# Environmental Minor Project Refinement Form

**Project Name:** West of Devers Upgrade Project **Request Prepared By:** Sylvia Granados

**Date Approval Required:** February 11, 2022 **Variance Request No.:** 53

*Southern California Edison*  
**West of Devers Upgrade Project**  
**Proposed Work Area**  
MPR #53  
WA-3-3X64-MPR-53 Gabion Install

FIGURE 1

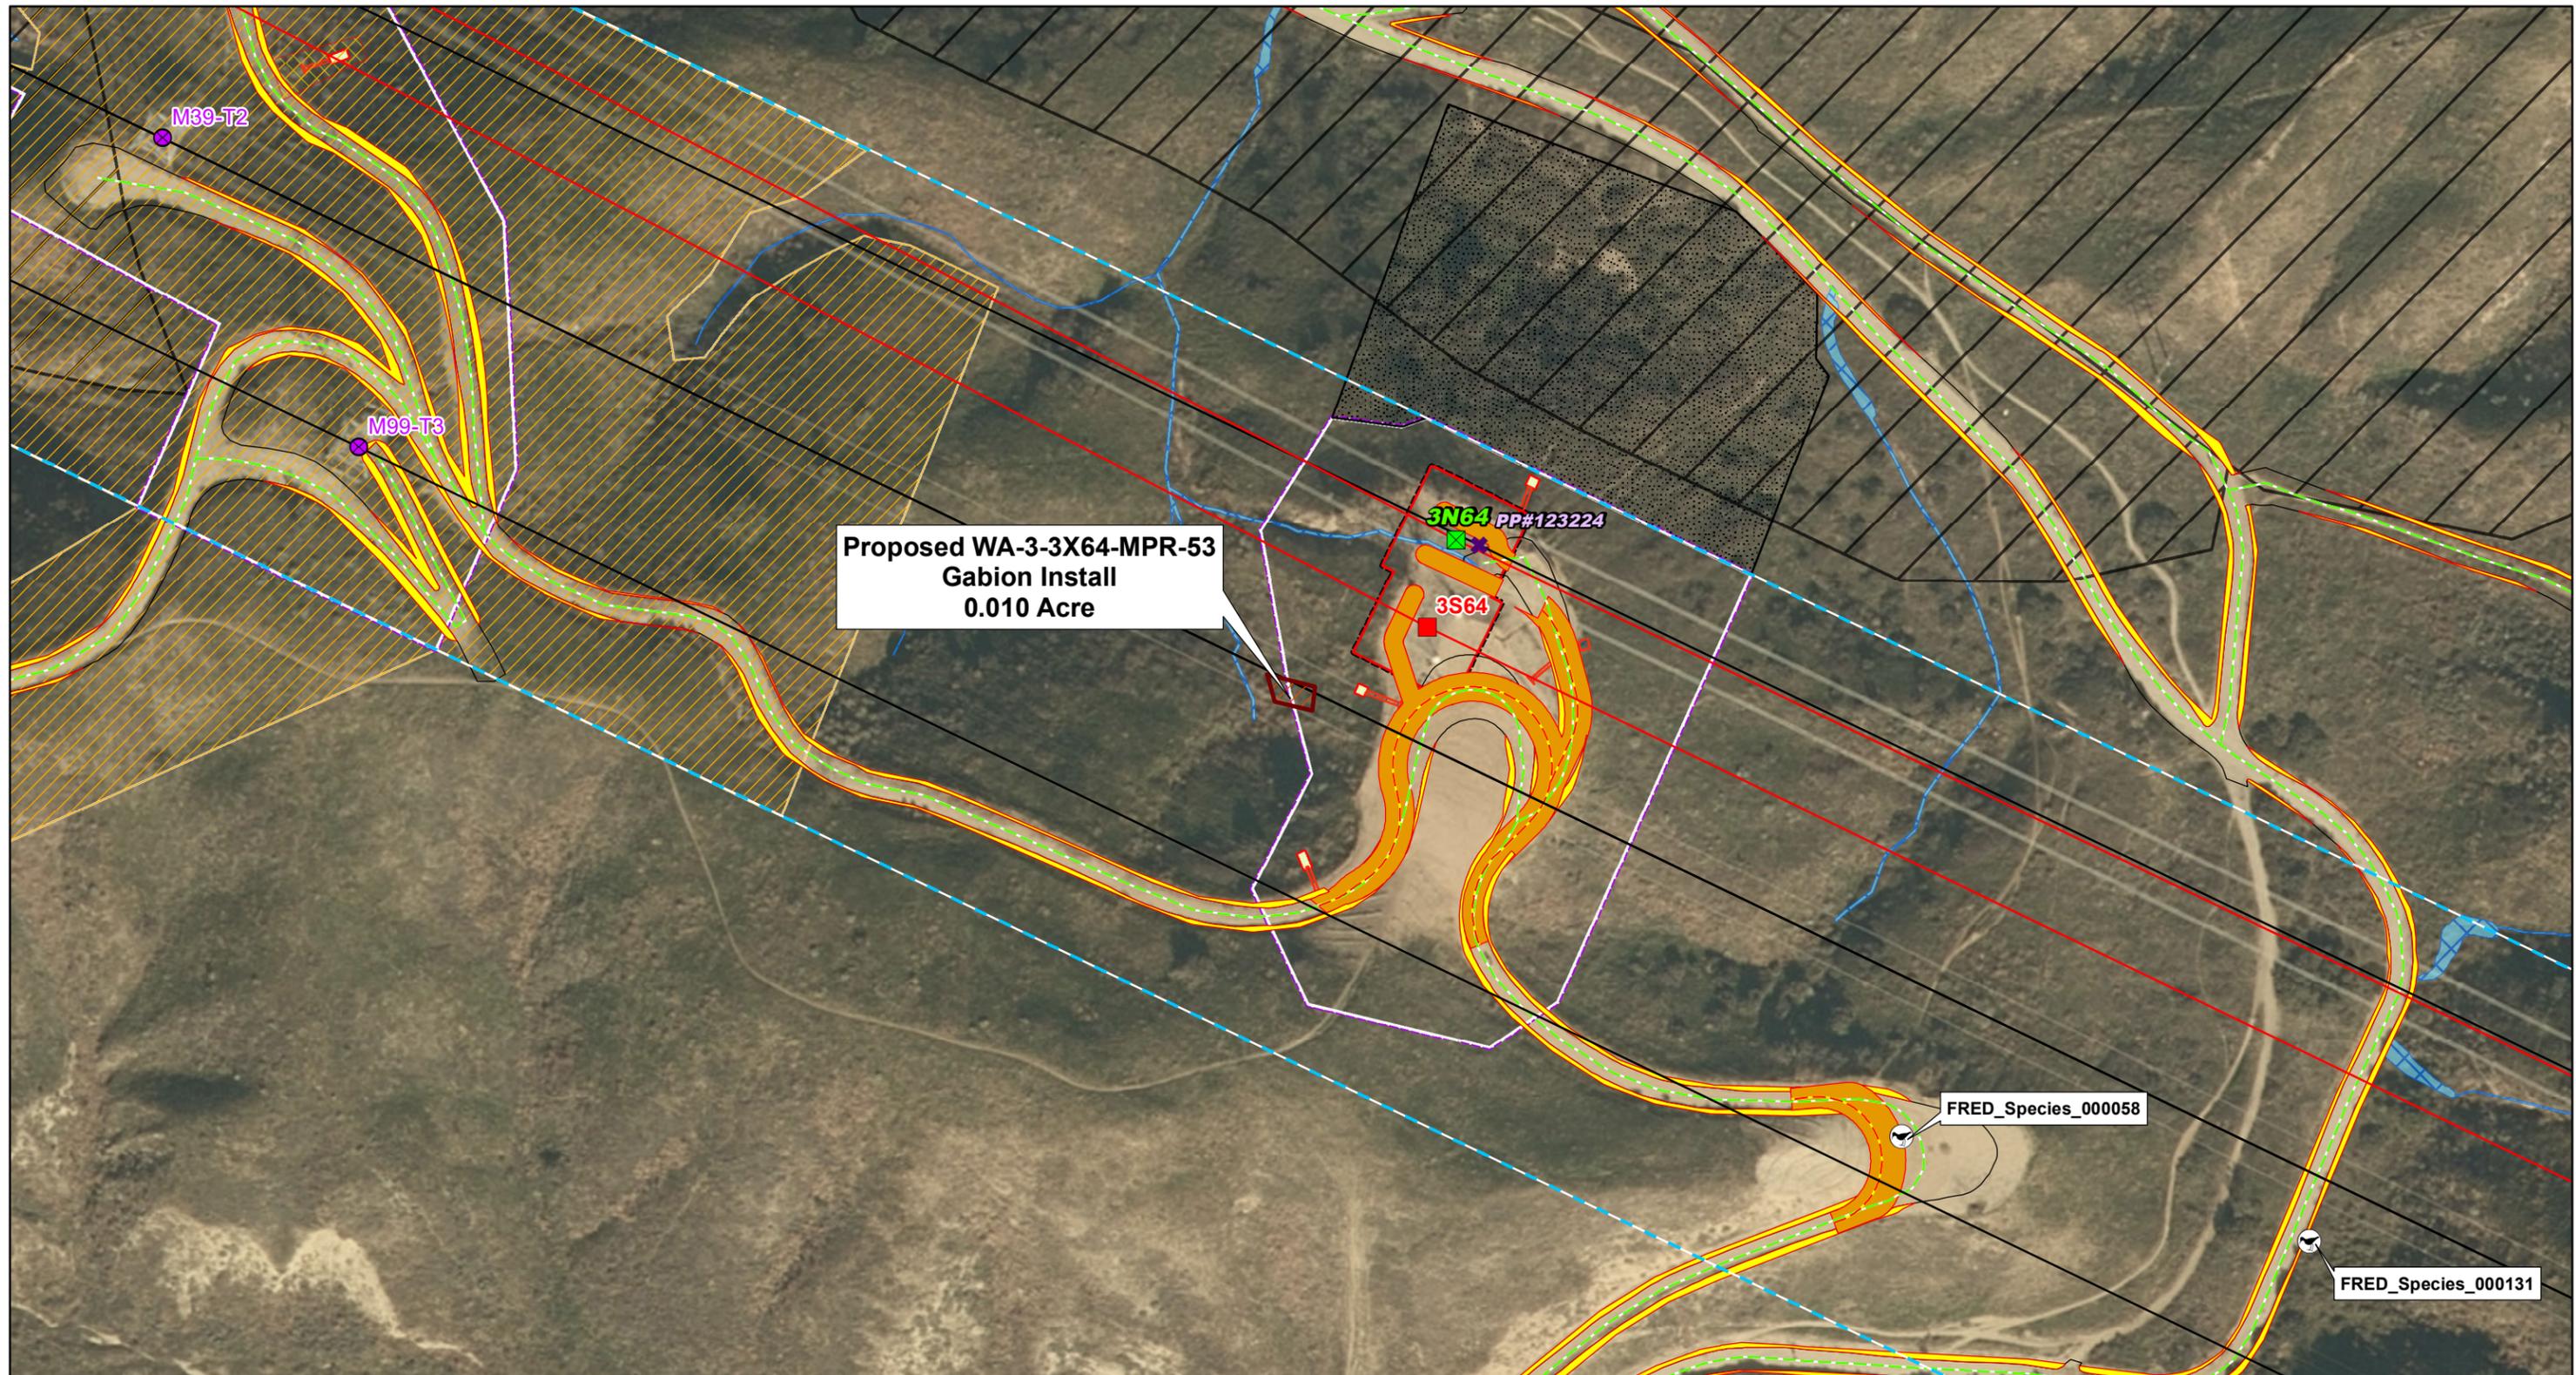
### WA-3-3X64-MPR-53 (Figure 1, page 1)

A 0.01-acre temporary work area is required immediately southwest of Tower Site 3S64 for the installation of an extended McCarthy Flume and Gabion Dissipator. This work is required to address on-site erosion and maintain slope stability. Drainage improvements will include re-contouring to repair existing erosional rills and features caused by offsite discharge to the upland area. Prior to installation, loose or yielding soil may be over-excavated and re-compacted. Temporary BMPs will be installed to prevent impacts to the non-wetland jurisdictional feature to the west of the work area during construction activities.

The new work area, shown on Figure 1, page 1, is located entirely within the existing transmission line right-of-way, in area owned by the City of Loma Linda, consisting of approximately 0.10-acre of grassland/forbland.

**Stephens' Kangaroo Rat** – Stephens' Kangaroo Rat Mapped Suitable Habitat (SKR) is located approximately 250 feet north of the new work area (Figure 1, page 1), but does not intersect the work area. A habitat assessment, pedestrian surveys, and several consecutive years of trapping surveys have been conducted within SKR suitable habitat areas of the Project. Based on a lack of historic data, habitat conditions, and negative results over several years of surveys, SKR are not expected. Therefore, no impacts are anticipated.

WA-3-3X64-MPR-53 is located within an area of very high PFYC 5 paleontological sensitivity, therefore, the site requires full-time, qualified paleontological construction monitoring if holes larger than 2-feet in diameter are drilled or if grading is required.
